INDESIT company

Model type:
IDL60EU

Commercial code:
F030644

N1045072FIG1

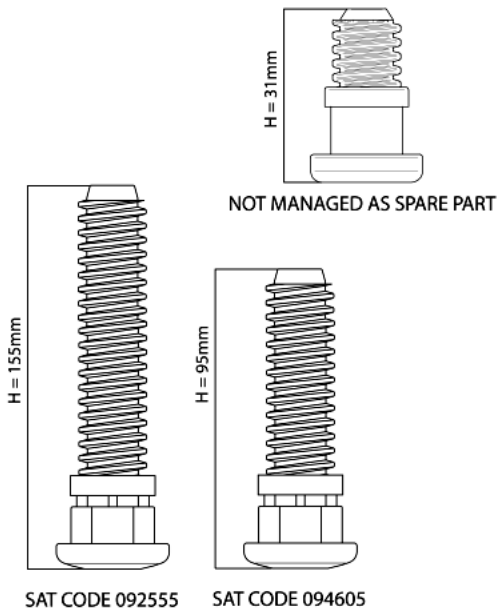
N1045072: Introduction of fixed rear foot H=31mm on free-standing models.

From serial no. 40218.0001, free-standing dishwashers affected by this modification have been equipped with new fixed rear feet (H=31mm).
The new foot replaces the adjustable one (H=155mm) Service code 092555; on the EVO3 range with TurboDry the new foot replaces the adjustable foot (H=95mm) Service code 094605.
The Spare Part Warehouse will continue to manage only 155mm and 95mm adjustable feet as they are interchangeable with the fixed 31mm foot.
The three feet are shown in illustration N1045072FIG1.

N1045083FIG1

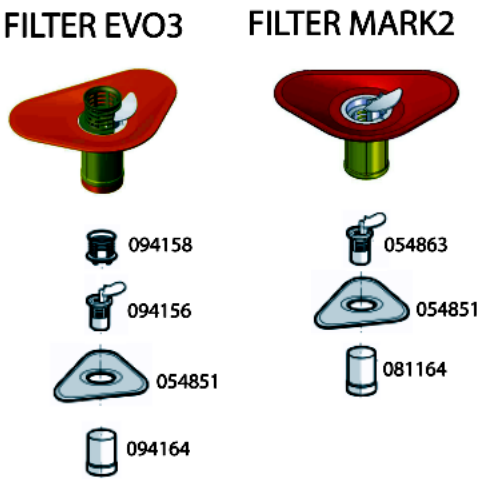
n1045083: Modification of filters on EVO3 60 cm dishwashers

All dishwasher models affected by this modification have been equipped with the items listed below, in order to solve the drain pump clooging problem.

Introduction of:
Cylindrical plastic filter code 081164
Central filter code 054863

Elimination of:
Cylindrical plastic filter code 094164
Central filter code 094156
Central filter grid code 094158

The modification has been introduced progressively, starting from serial no. 40516.0001.

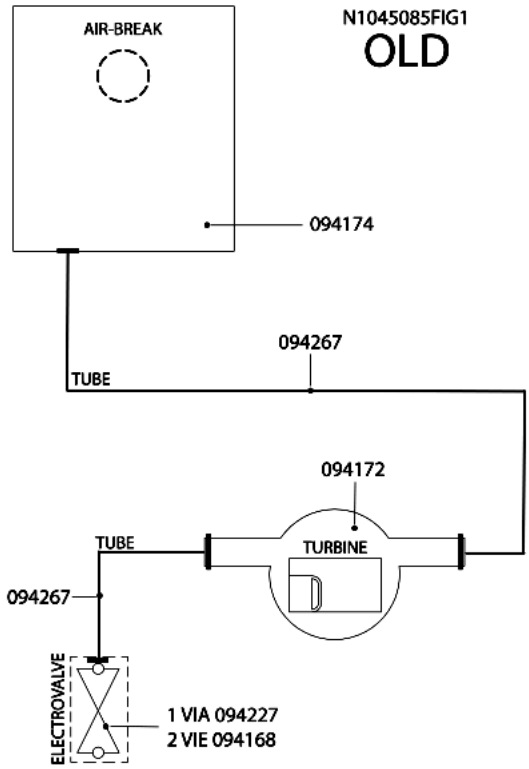
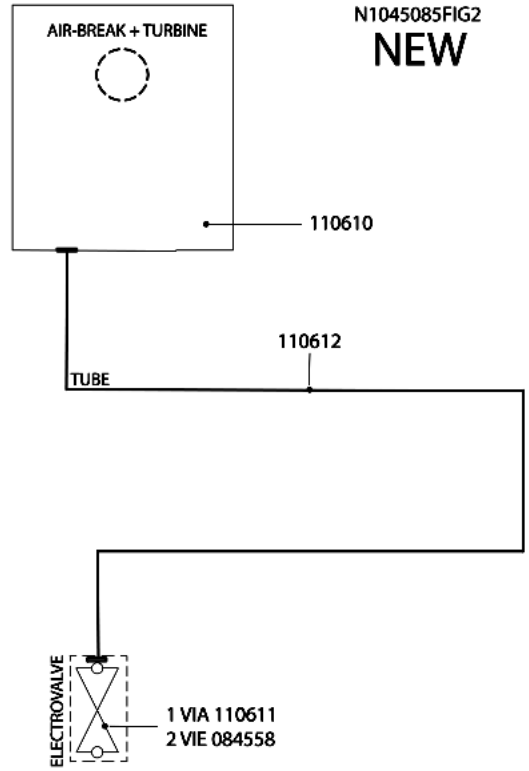
n1045085: Introduction of new litre counter turbine integrated on air-break.

All dishwashers affected by this note have been equipped with a new litre counter turbine on the air-break.
Picture N1045085FIG1 illustrates the premodification structure, picture N1045085FIG2 the new structure.

Items affected by the modification.

AIR-BREAK:
new 110610;
premodification 094174;
the new item features a new integrated litre counter turbine and its water supply hose has a smaller diameter.

LITRE COUNTER TURBINE code 094172 has been eliminated.

SOLENOID VALVES:
new:
1-WAY code 110611;
2-WAY code 084558(Rohs 143737);
premodification:
1-WAY code 094227;
2-WAY code 094168;
the new solenoid valves have a smaller diameter drain hose fitting.

HOSES:
new solenoid valve hose/air-break code 110612;
premodification turbine hose/air-break code 094267;
premodification solenoid valve hose/air-break code 094267;
the new hose has a smaller internal diameter.

WIRING:
the litre counter turbine connecting cable is longer, but since the connector is the same, the new item can be used in place of the premodification one.
